Summary of Review on Civil Engineering  
and Technical Infrastructure  
Requirements for FCC Experimental Sites  
October 3-4

Detector Concept Meeting  
7 November, 2022

# The Review 3-4 October

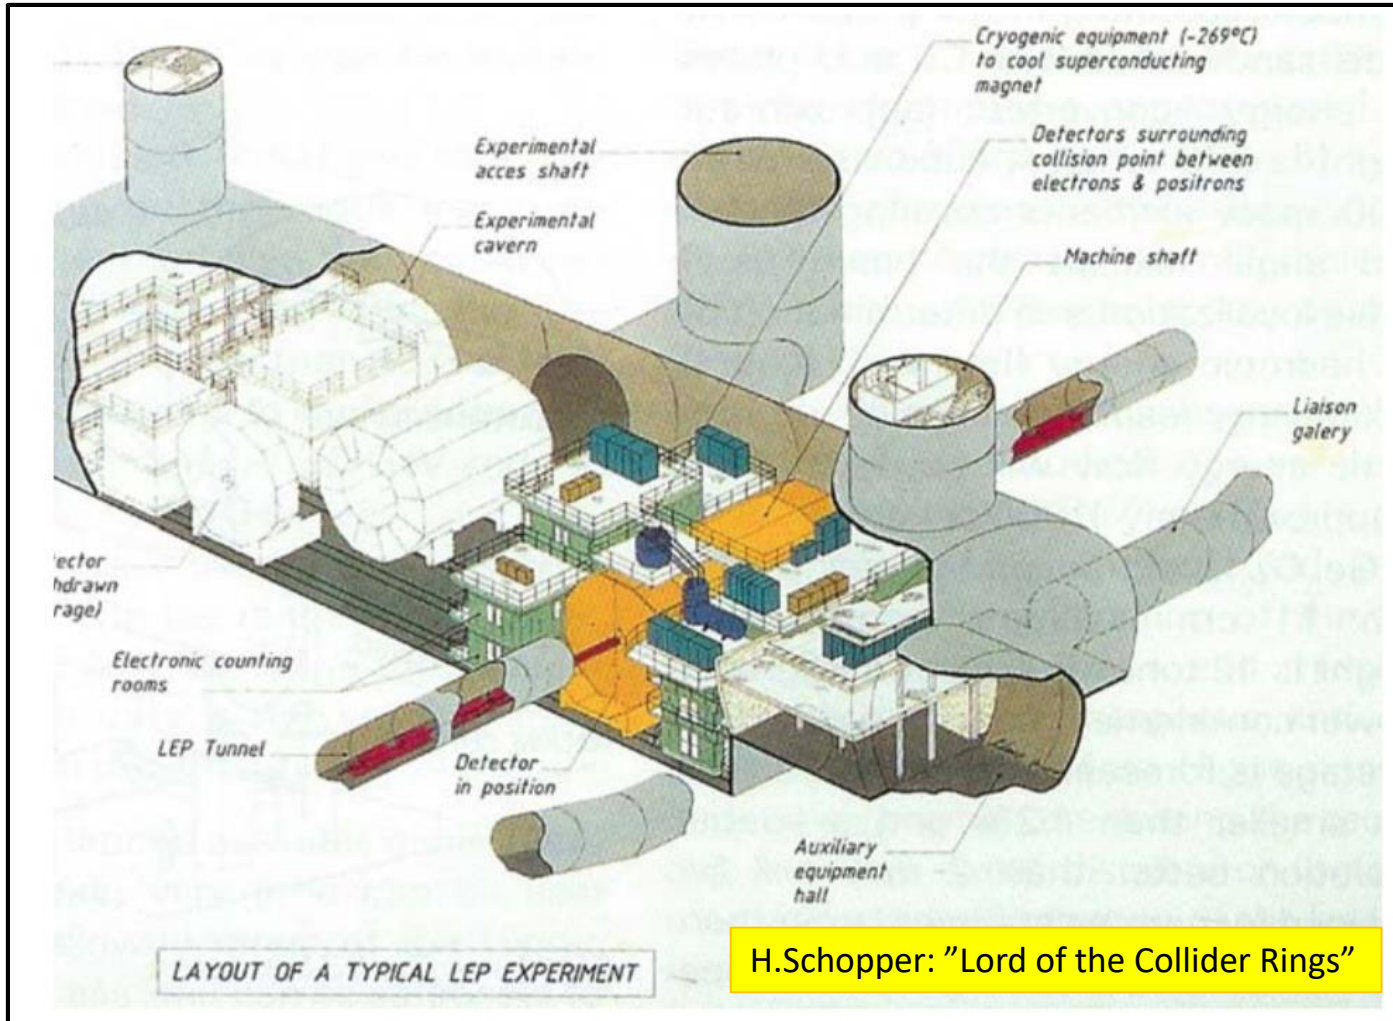
- The committee endorses the baseline concept for the FCC experiment site underground structures of an experimental cavern with a single experimental shaft for the main detector installation, linked via a transfer tunnel to the service cavern, with a second shaft, and connected via bypass tunnels to the machine tunnel on either side of the experimental area. This is an effective and efficient solution, taking into account also experience from LEP and LHC.

Shaft diameter: 17m

- The committee recommends that the cost change which would be produced by a change in the main cavern size be evaluated, in the event that it is possible to consider a smaller width than the default 35 m, perhaps as low as 30 m. Length: 66m
- The decision to operate the cavern with a single shaft has implications for the logistics of the detector installation and operation which need to be studied.
- Secondary experimental caverns could be of CMS size and costed for this. Height/Width: 25m; Length: 55m
- We recommend that the construction of the service caverns, even though not strictly required for FCC-ee, be not staged, subject to proper cost estimates being checked for initial and staged construction. Also essential for FCC-ee, to keep machine cryogenic equipment vibrations far from the beam.

# FCC-hh Reference Detector

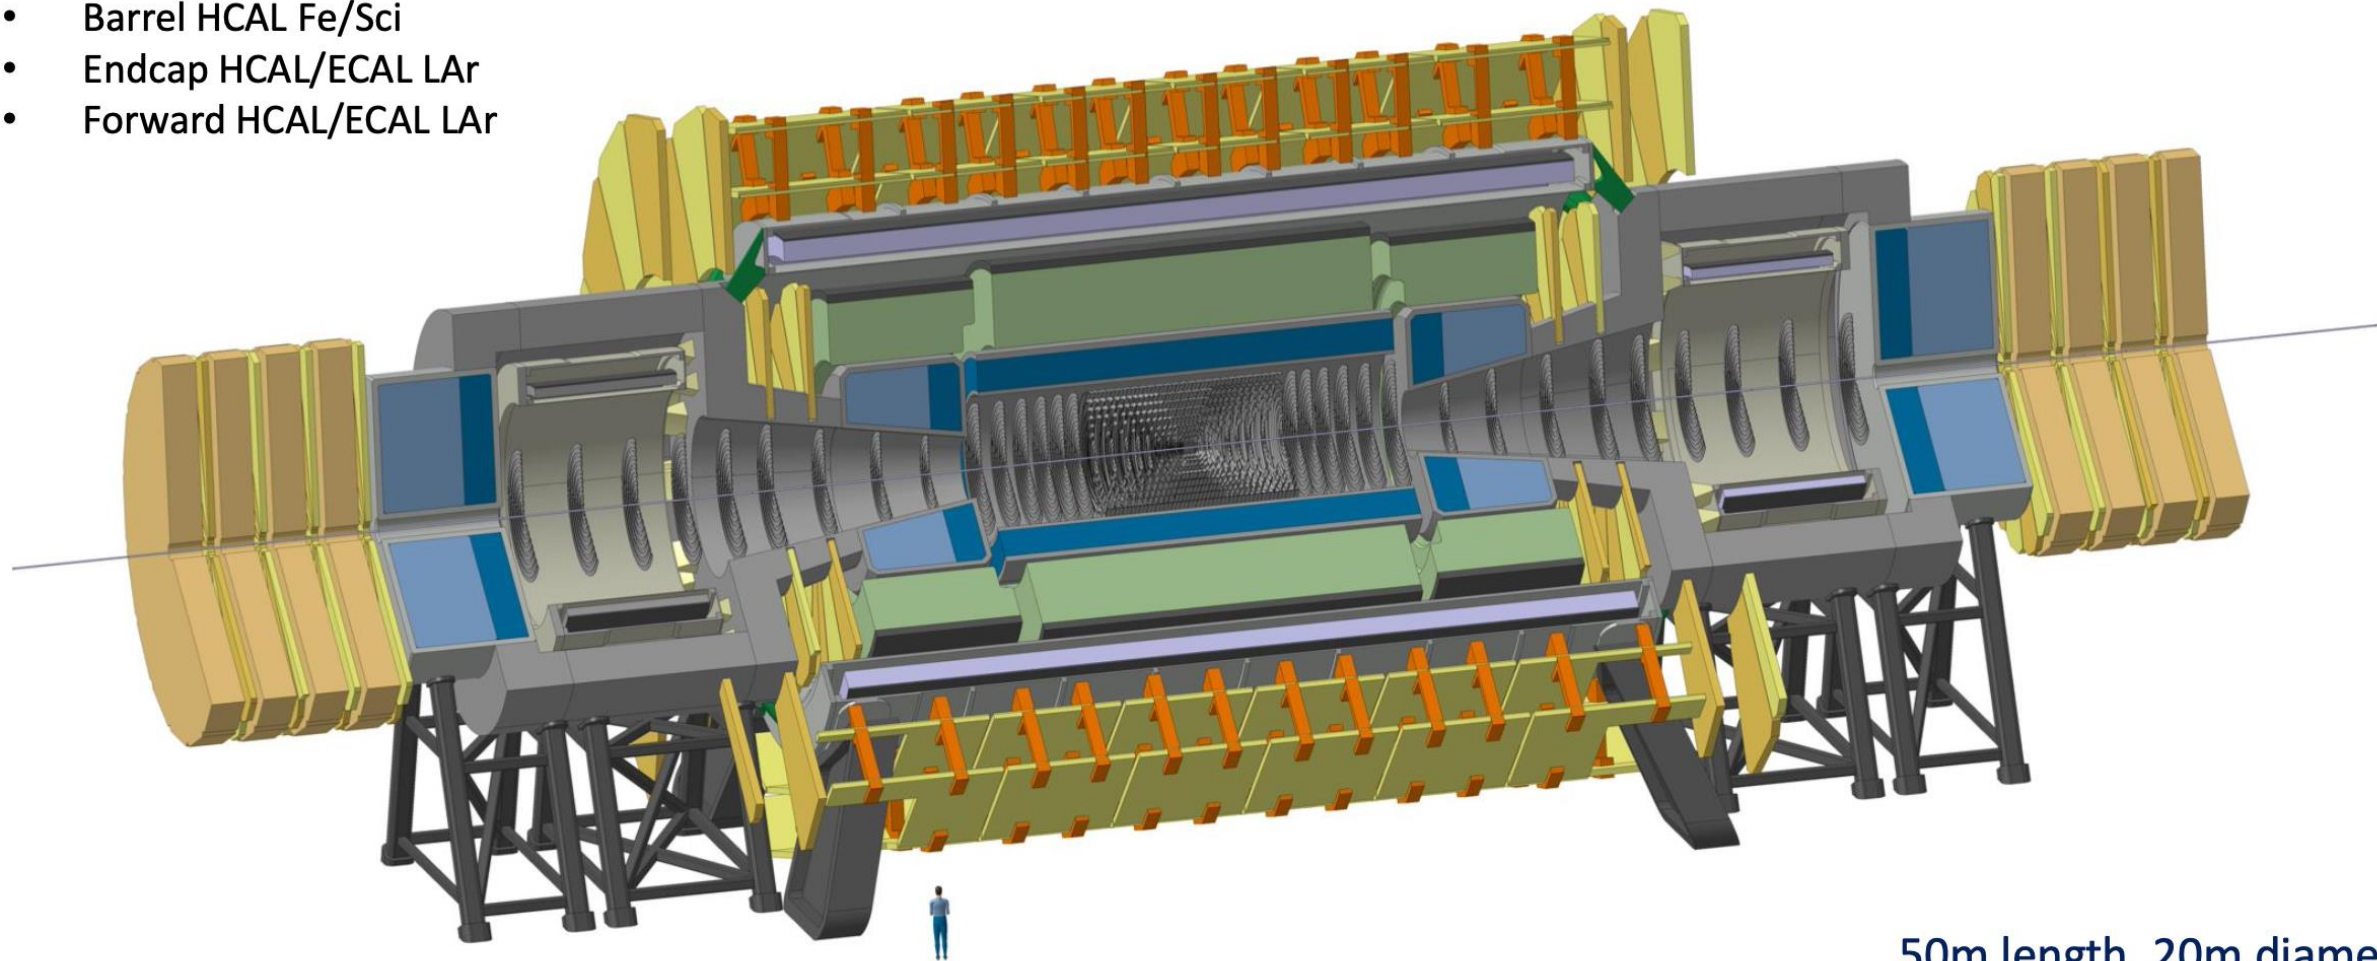
- The committee is not yet convinced that all the implications of the large stray field from a detector magnet without a return yoke, as proposed for the two FCC-hh general-purpose experiments, are fully understood.
- Therefore, we recommend that the option to build a return yoke is retained, and this option should be costed.
- This recommendation may have implications for the default cavern size.
- Working solutions for the effects of the stray field on all active components and passive structures nearby, including cranes, lifts, access and safety systems, as well as experiment-related infrastructures such as coolant pumps need to be considered, together with the cost of novel solutions, and the implications for operations.
- The option to build a return yoke should only be discarded when convincing solutions to the above issues are in place.

The cost and weight of a yoke that returns the magnetic flux is considered excessive.

# A side issue: Position of the booster ring

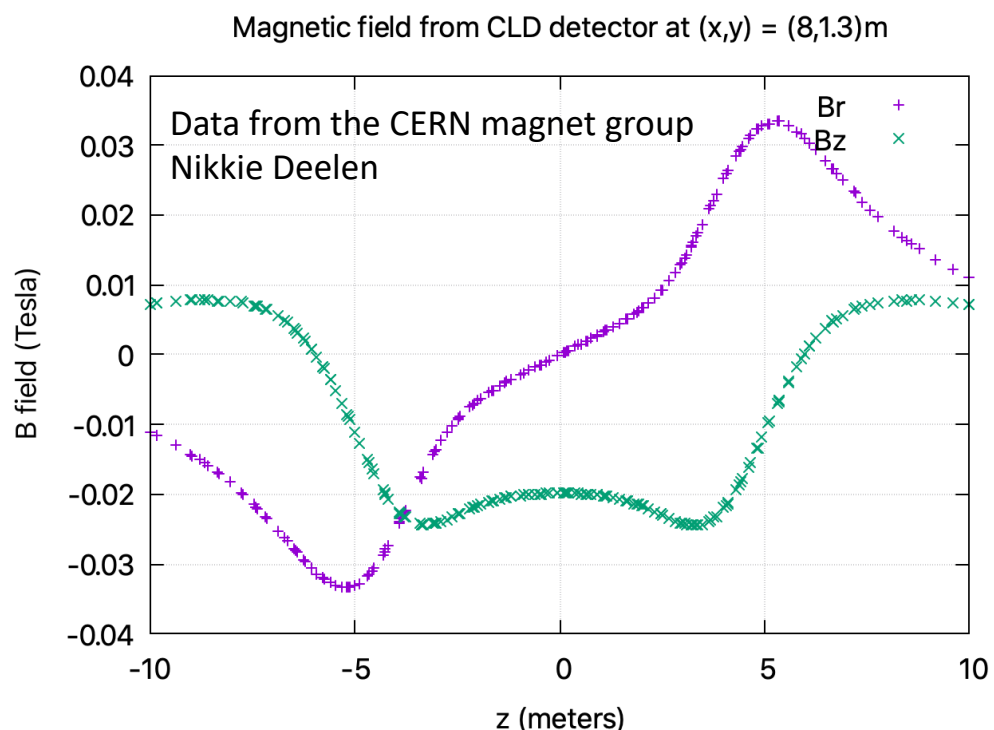
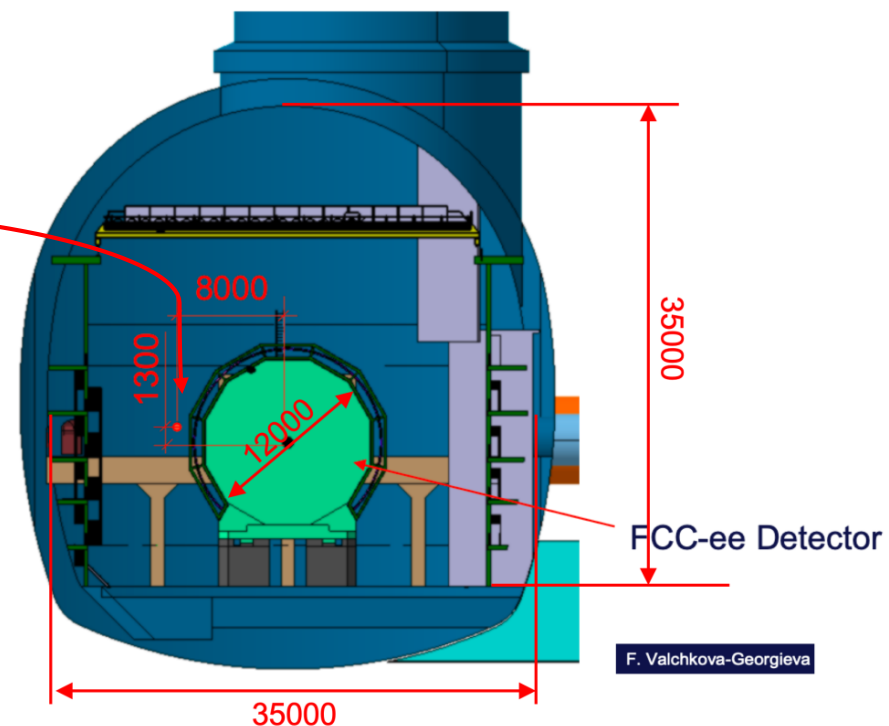
- Booster position may have consequences on the tunnel layout around the IP
- For this study, booster ring passes through cavern outside detector volume at  $[x, y] = [8.0, 1.3]$  m
- Detector stray field at the booster location is up to ten times stronger than the 3 mT dipole field strength at injection
  - Needs to be corrected for

A solution for shielding and/or correction has to be developed

- The booster location must be such that there is at least 1 m free space around the detector envelope with the shielding/compensation in place
- The shielding/compensation must not sizeably affect the magnetic field of the detector.
